October 21, 1976
IE-76-1601

Transmitted herewith, in accordance with the requirements of 10CFR50.59 and 50.90, is an application for amendment of DPR-49 to incorporate proposed changes in the Technical Specifications (Appendix A to license) for the Duane Arnold Energy Center (DAEC), described in the enclosure hereto.

PROPOSED CHANGE RTS-73 TO DAEC TECHNICAL SPECIFICATIONS

FIGURE 3.12-5

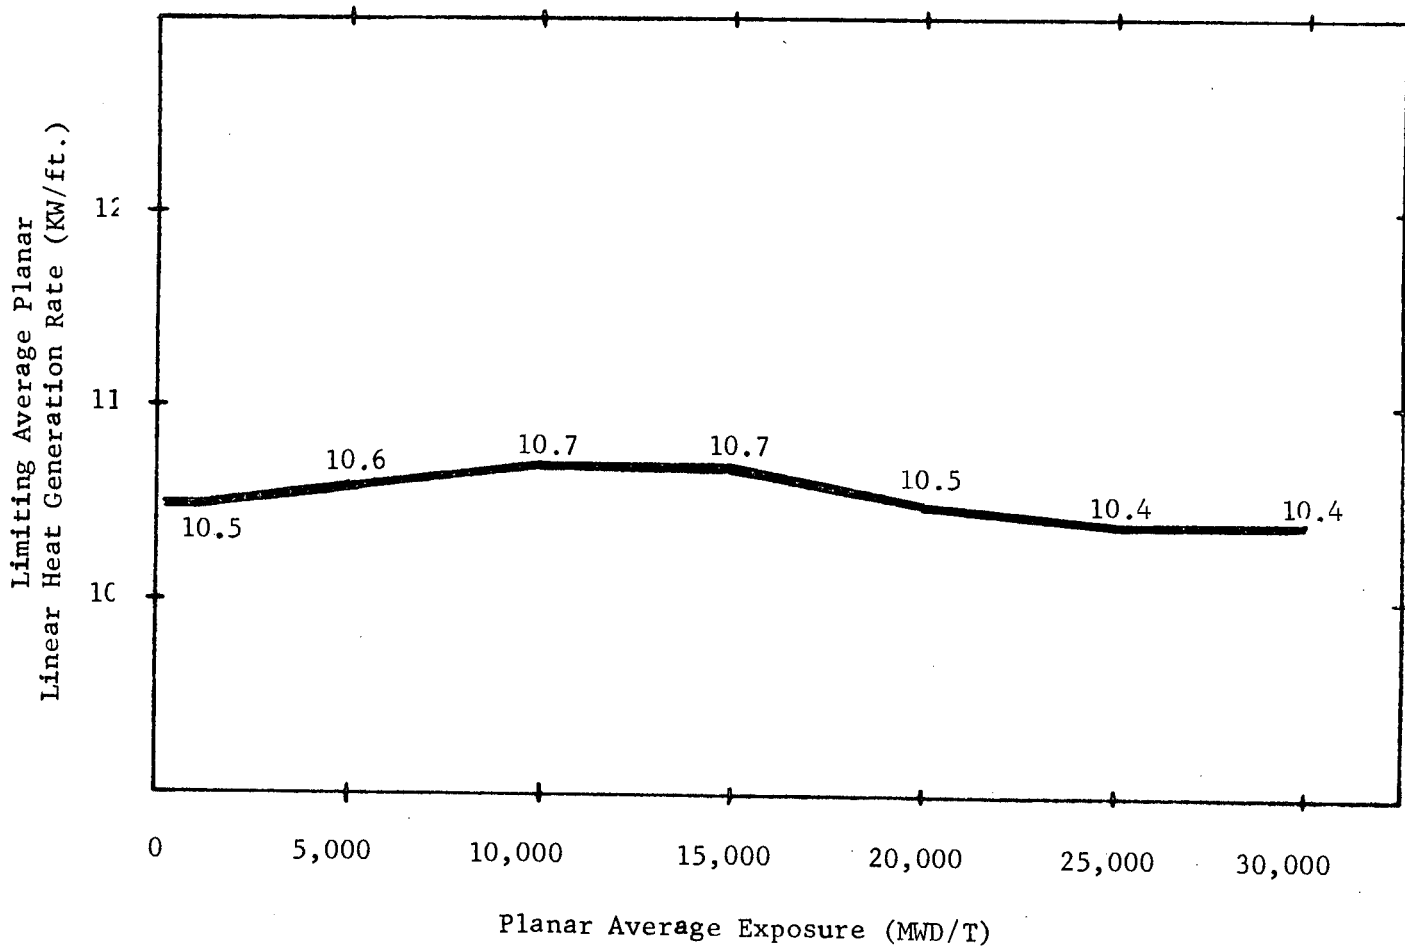
Remove the present Figure 3.12-5 and replace it with the attached Figure 3.12-5.

This change is being proposed because it has been found that the present MAPLHGR curve for plugged 8 X 8 fuel is in error.
